# COUNCIL ASSESSMENT REPORT

<b>Panel Reference</b>	2019HCC002
<b>DA Number</b>	DA/1483/2018
<b>LGA</b>	Central Coast
<b>Proposed Development</b>	Masterplan development application for mixed use development comprising 102 residential units, retail space and car parking
<b>Street Address</b>	10 Denning Street & 1-5 Short Street, The Entrance Lots D, E, F & G DP 348224, Lot 1 DP 102735, Lot 11 DP 17376, Lots 1 & 2 DP 1219145
<b>Applicant/Owner</b>	Central Coast Council
<b>Date of DA lodgement</b>	14 December 2018
<b>Total number of Submissions Number of Unique Objections</b>	<ul style="list-style-type: none"> <li>• 1st notification: 3 individual submissions</li> <li>• 2nd notification: 17 individual submissions</li> <li>• 3rd notification: 13 individual submissions</li> </ul>
<b>Recommendation</b>	Refusal
<b>Regional Development Criteria (Schedule 7 of the SEPP (State and Regional Development) 2011</b>	Clause 3 –Development with a CIV exceeding \$5 million and Council related

PREPARED BY GLN PLANNING FOR CENTRAL COAST COUNCIL

Figure 10 – Previously refused DA/624/2016 East Elevation

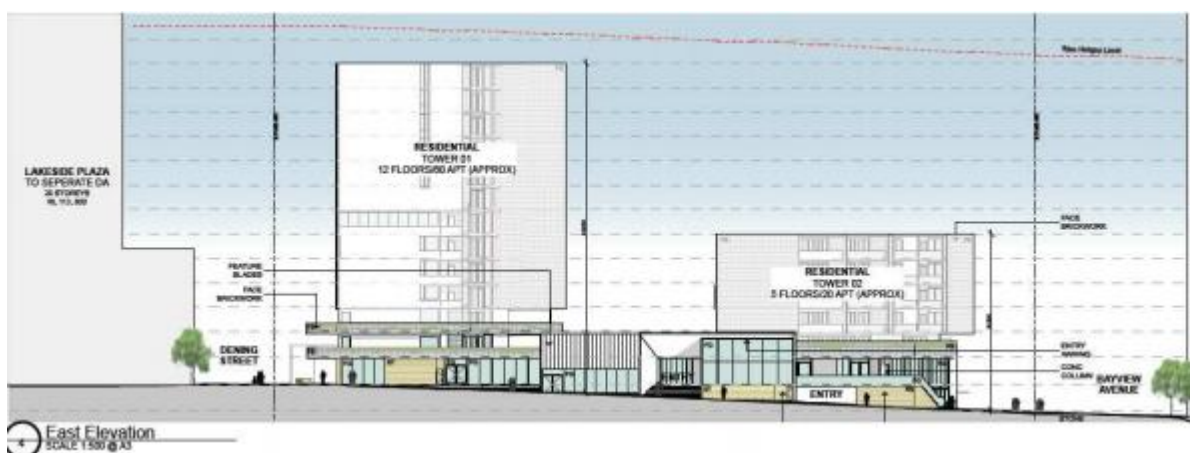
The current development application (see Figures 10 and 11 below) provides for a greater built form located opposite the site in Short Street being the Atlantis residential flat building at 1 – 5 Bayview Street. This is a result of relocation of the taller tower element to the northern part of the site to limit overshadowing of the proposed Town Square and adjoining properties to the south. Further there is an approximate reduction (50%) in the amount of commercial floor space, an introduction of podium parking level and an increase in residential unit numbers and floor space. The relative size of the two proposals is not a relevant consideration to the assessment of the application but rather compliance with the relevant controls. Both proposals fail to satisfactorily address the built form and urban design outcomes as identified in WDCP.

Figure 18– Proposed Parking Levels Dwg No DA-4005

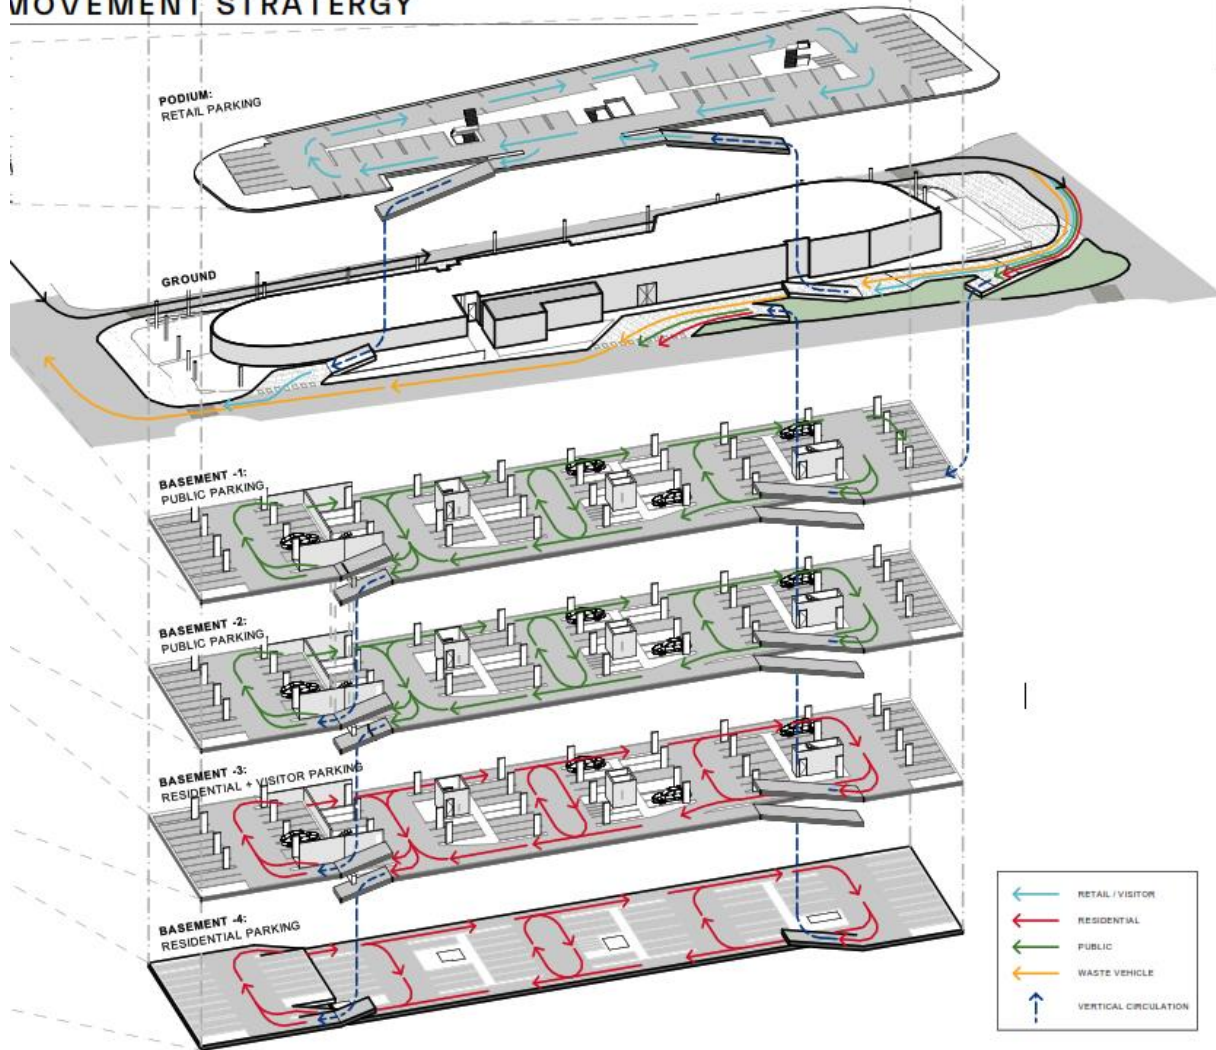
The residential and public car parks are proposed to have separate access ramps with entry from Bayview Avenue. Service vehicles will enter and exit the loading area from the Bayview Avenue driveway and travel in a forward direction to exit in Short Street.

The location of carparking is proposed to reflect to the different users of the mixed-use development. The residential and visitor parking is proposed in the two lower basement levels. The public car parking is located in the two upper basement levels. This eliminates any public access of the residential parking component.
